# CERRO COPPER & BRASS COMPANY

SUBJECT: DEEP WELL

Attached is a copy of the results of the test drilling made by Luhr Bros. on 7/10/70. Based on these results, the recommendation is made by both Luhr Bros. and the Testing Lab that a 30' long screen be installed instead of the proposed 20'. Obviously this will give us considerably greater potential capacity and greater life expectancy for this well.

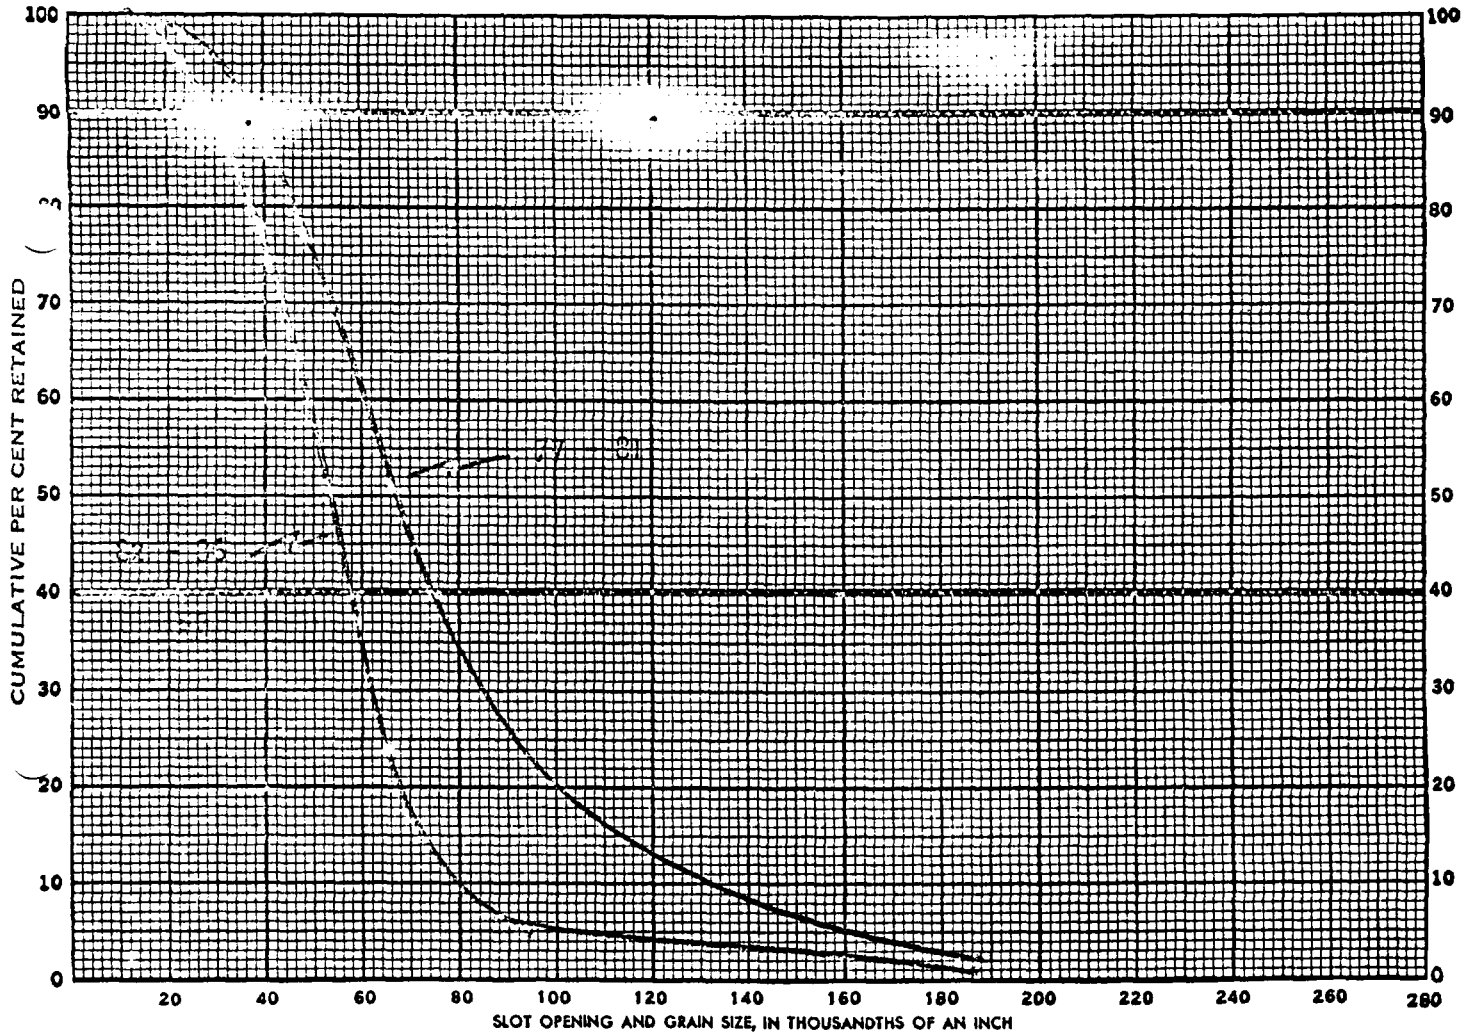
On the basis of this information our recommendation is the utilization of a #100 (0.100-inch) slot well screen with a No. 3 gravel pack material from Northern Gravel Company of Muscatine, Iowa.

Good well design dictates that for maximum efficiency from a water table well from one-third to one-half the aquifer thickness be screened. With the aquifer reported to be 75 feet thick at this location, the correct screen length for this installation should be a minimum 25-foot long and preferably 30 feet long.

Recommended Slot Opening: No. 100 (0.100-inch)  
with No. 3 Muscatine Material
